## Almonry Development Working Group

Notes from a videoconference on 22 July 2020

### Accessible toilet

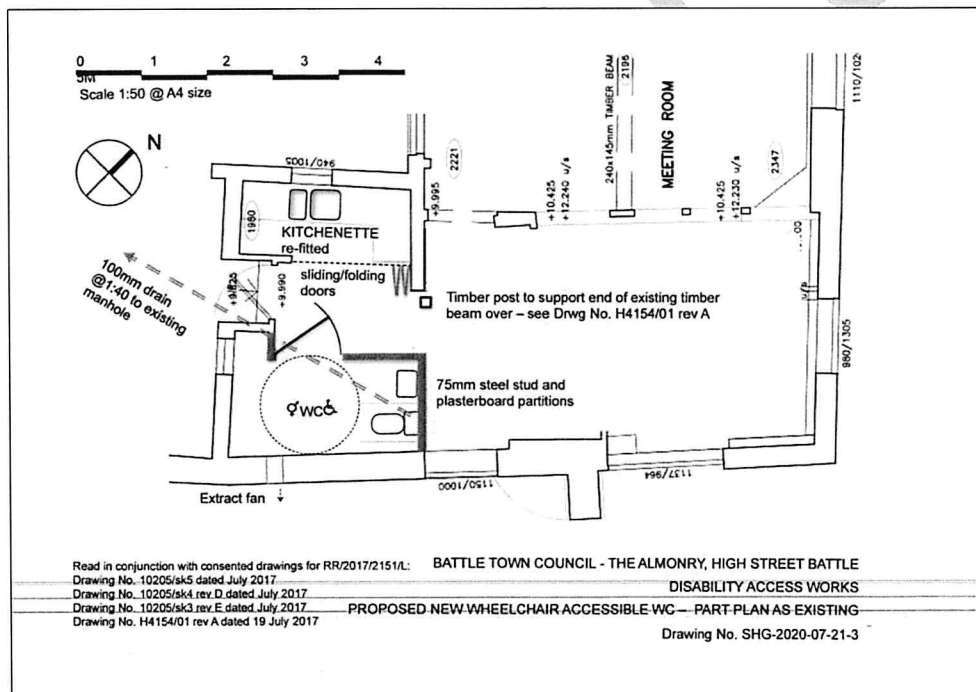
Several plans for an accessible toilet had been offered by members of the Working Group in an attempt to ensure the privacy and modesty of users. SG provided a solution for discussion.

By installing a folding screen across the kitchenette area, sufficient privacy would be provided to satisfy the working group. The WC will be positioned to enable access from both sides.

### Other toilet provision

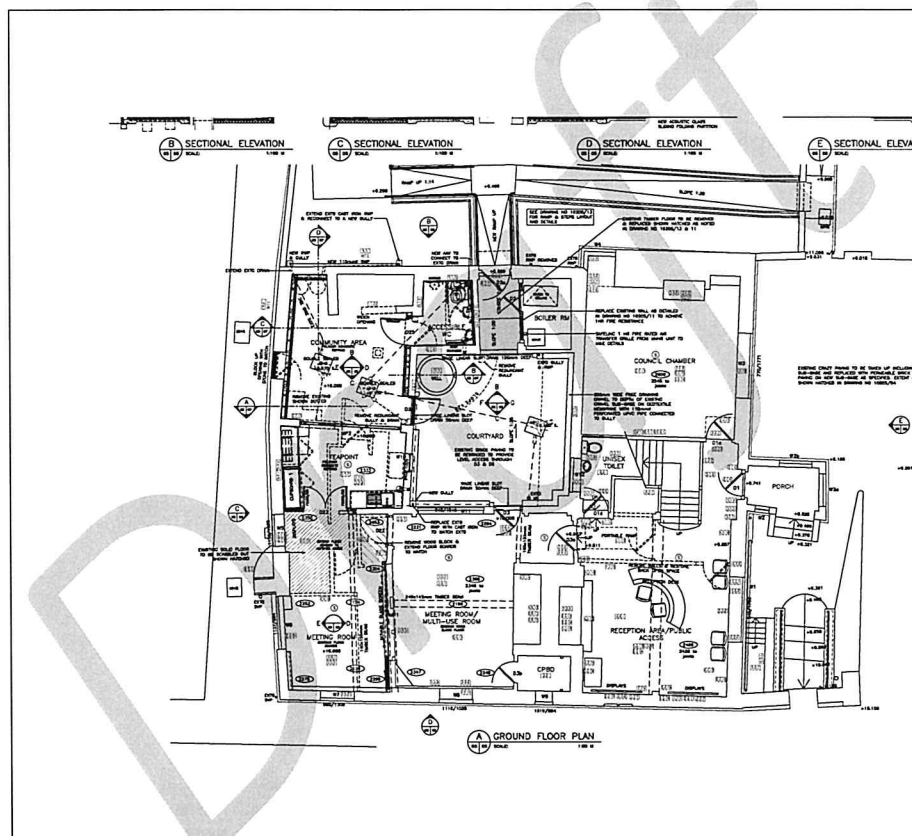
In order to ensure adequate provision for when the site is being used to capacity, it had been agreed that the Working Group would recommend to Council that the outside toilet is given a face-lift to provide two basic WC cubicles. This facility would then also be available for the use of visitors to the garden and the Museum. However, SG now believes that the three toilets (two on the ground floor and one on the first floor) should be sufficient. Council may decide to undertake a basic face-lift of the outside toilet within the current works or leave it for a later phase.

## Ramped approach from front garden to existing entrance

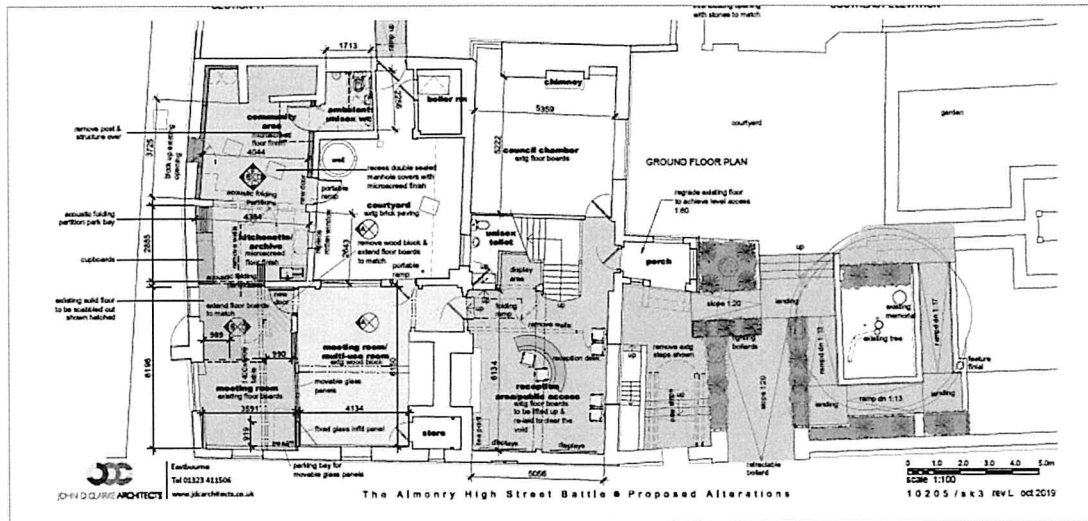
This design was rejected by Council in 2019.

## Ramped approach for High Street Gate to existing entrance

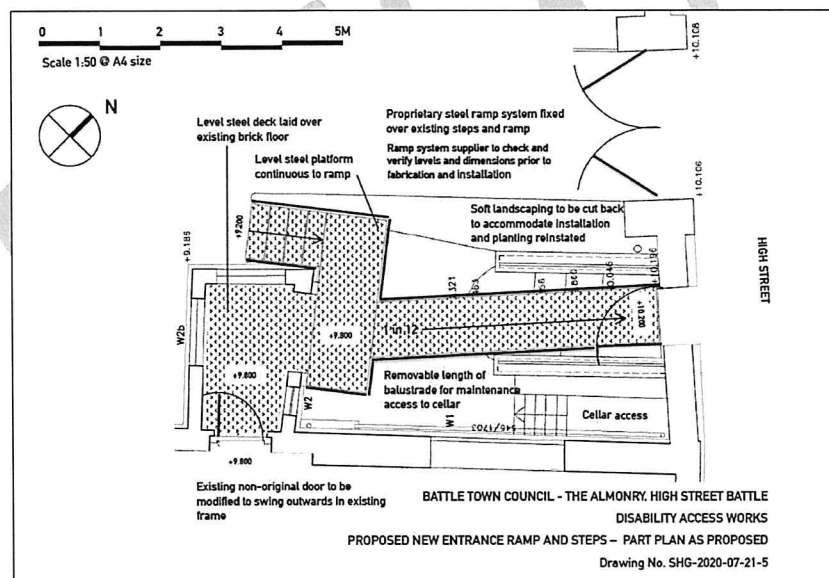
The 1 in 12 ramp is just acceptable. Visitors needing level access will need to go back to the High Street and use the driveway to access the Museum from The Almonry. Visitors unable to negotiate a slope will not have stepped access from the High Street, although there are steps from The Almonry to the sloping driveway.

### Platform lift behind porch

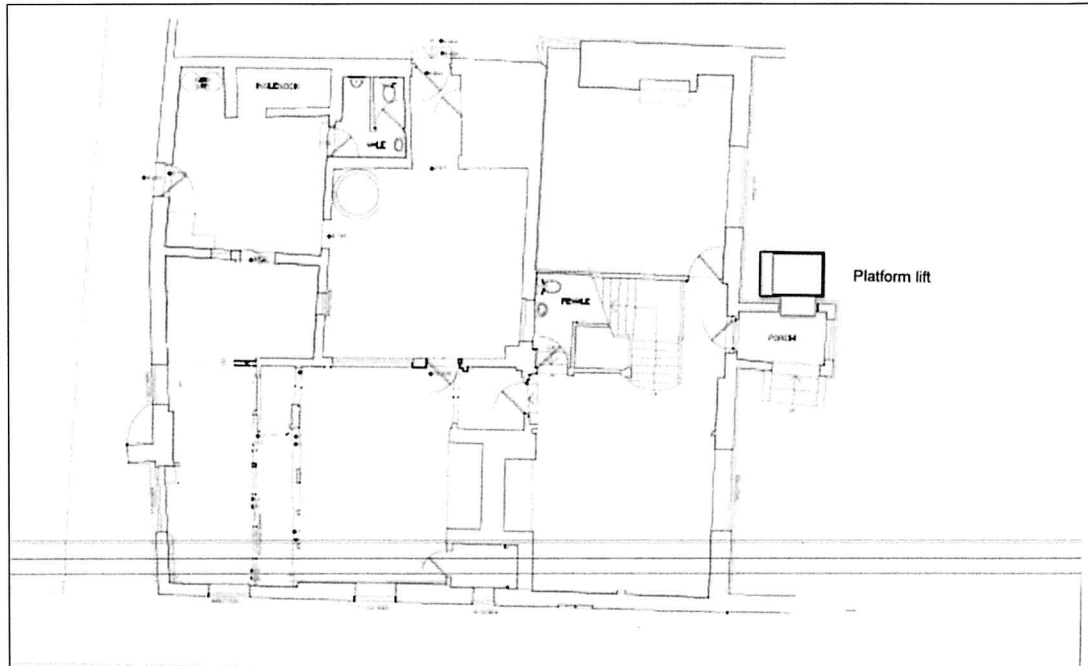
This solution had previously been discounted as unfeasible, partly due to the surface and steepness of the driveway from the High Street. However, SG will draw up a plan to raise the level of the porch floor, re-hang the main door to open outwards and install an enclosed lift.

The removal of the partition in the hall by the stairs, as in the plans that have already received Listed Building consent, would not only give a feeling of space, but, more importantly, add light for visually impaired people.

The Working Group recommends the lift option to Council.
